Illustrated Parts List - IPL Update

365 X-TORQ

503 63 76-03/04

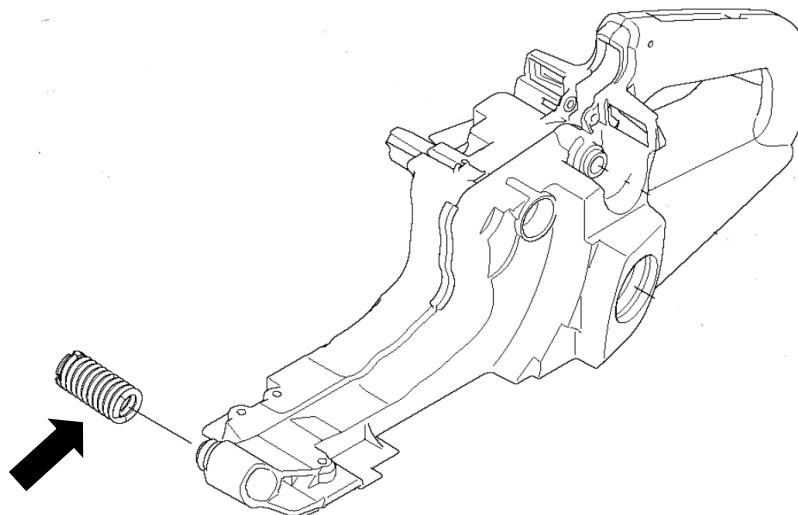
New Antivibration element with ground top on the metal spring. The plastic plug is changed. This gives longer thread length and therefor better fastening of spring in plastic plug.

Reason: Improved durability of antivibration element.

New articles Antivibration element 503 63 76-03 and 503 63 76-04(hard)
